MAYOR AND COUNCIL COMMUNICATION

AGENDA ITEM: Legends of Lake Elmo OP Concept Plan Review

City of Lake Elmo Planning Department
OP Development / Concept Plan Review

Re: Legends of Lake Elmo – OP Concept Plan Review

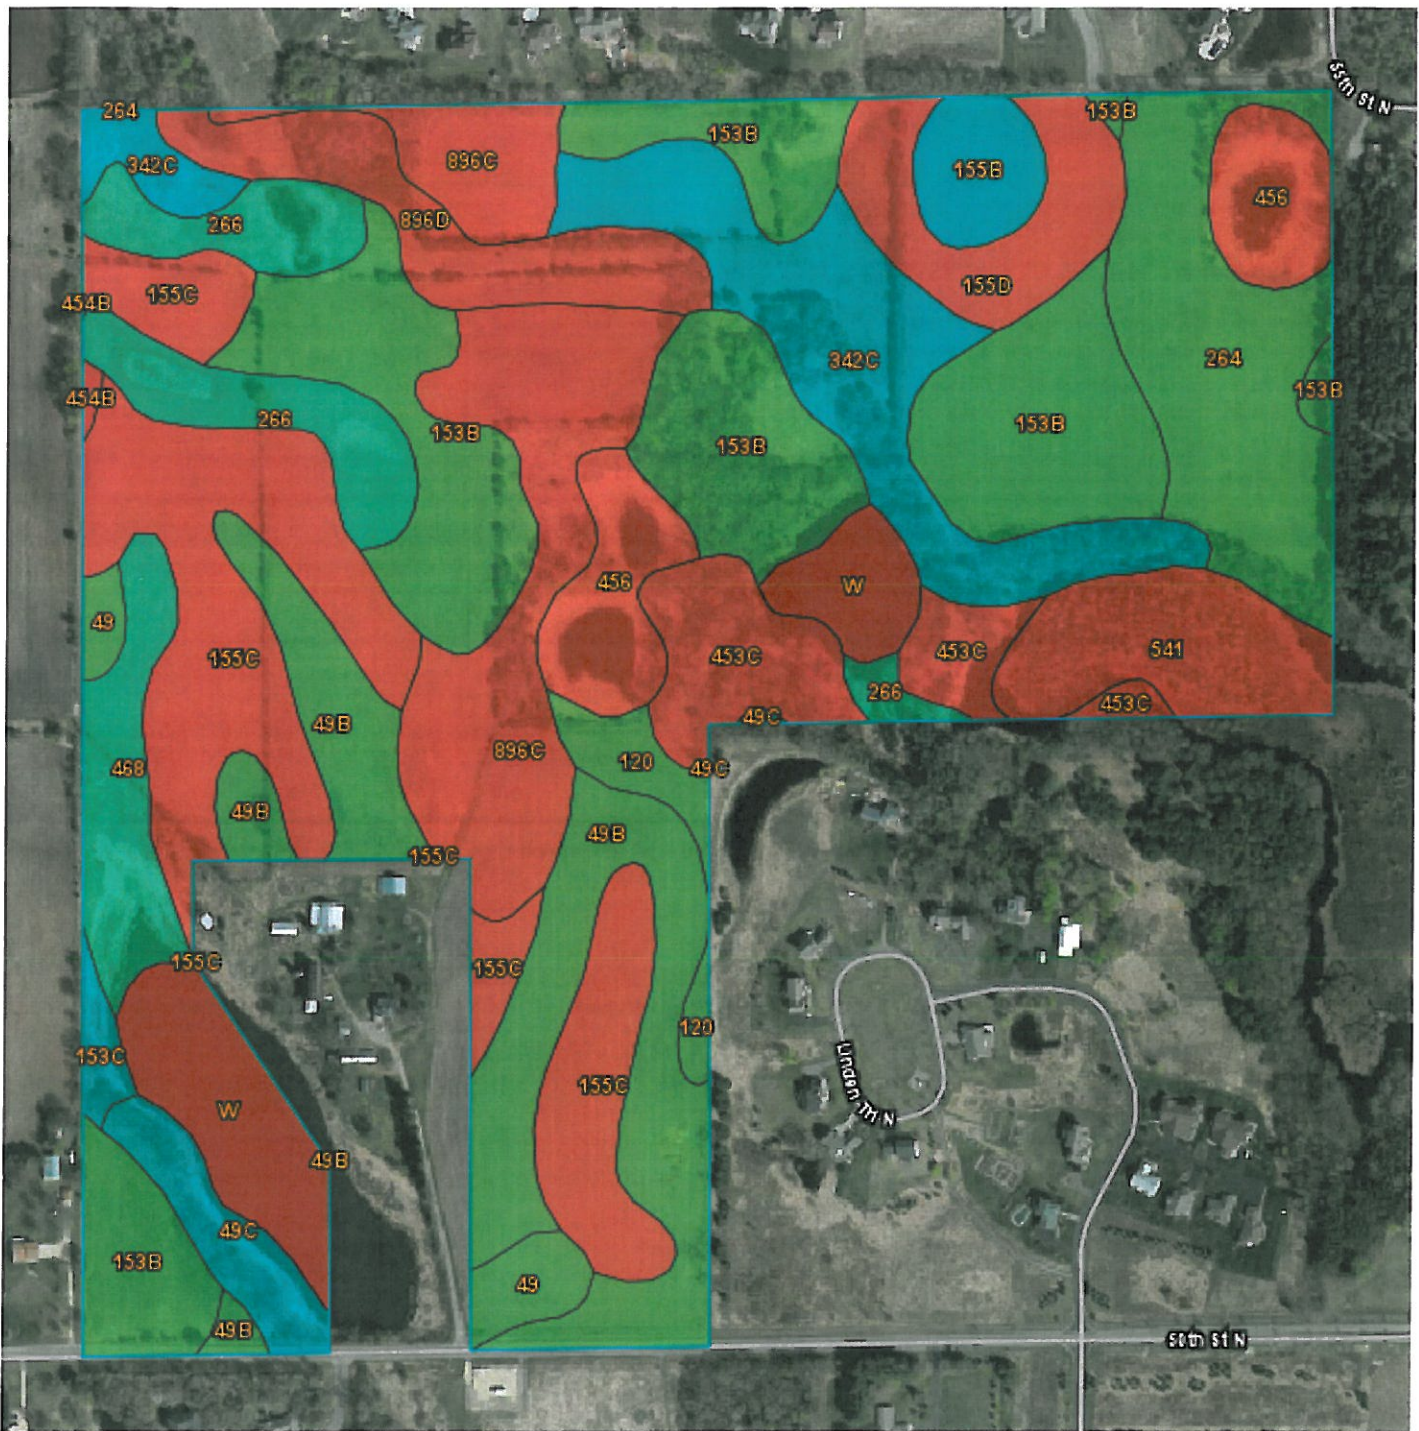
Staff comment: The applicants have amended the plans to include one acre lots and are proposing on-site septic facilities. Per the concept narrative:

Please see engineering comments on wastewater on page 17 of this report for further comments on septic facilities.

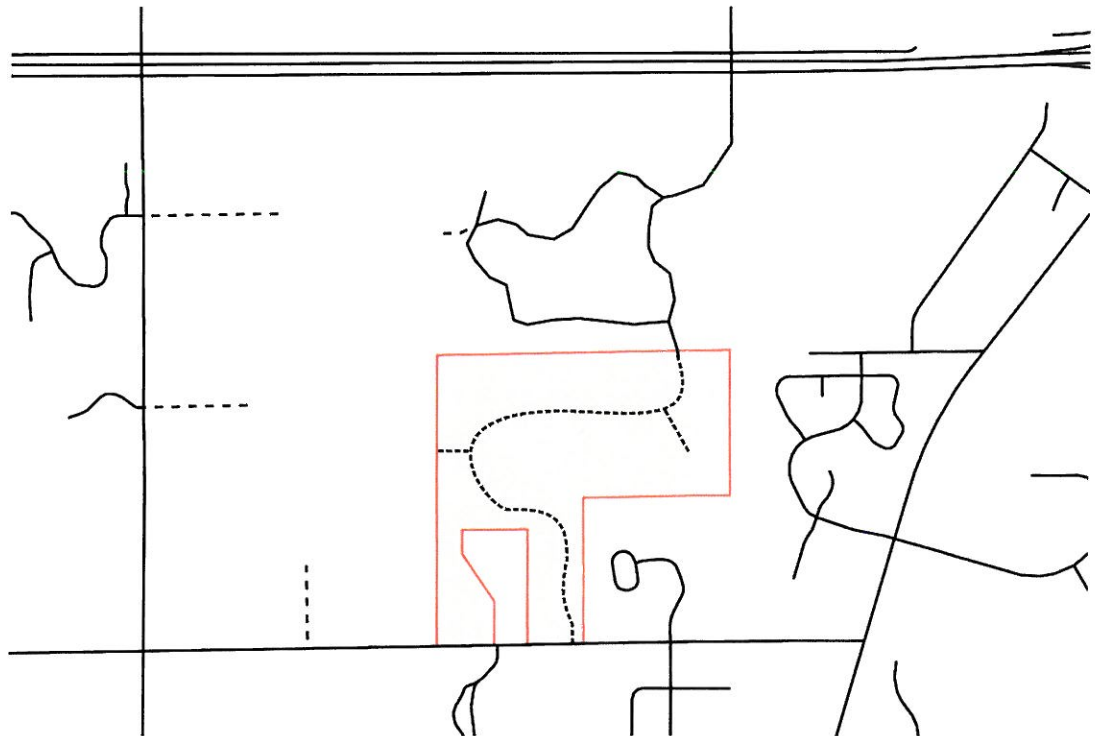
Staff Comments: As indicated in the staff reports on previous concept plans, a critical pedestrian connection that will be required by the City is the construction of a bituminous trail on the north side of 50th Street connecting the two sides of Outlot C and extending to the westerly limits of the Plat. This connection must be shown on any future preliminary application. Other than that, the requirements for pathways appear to be met by the proposed plans. **Criteria met.**
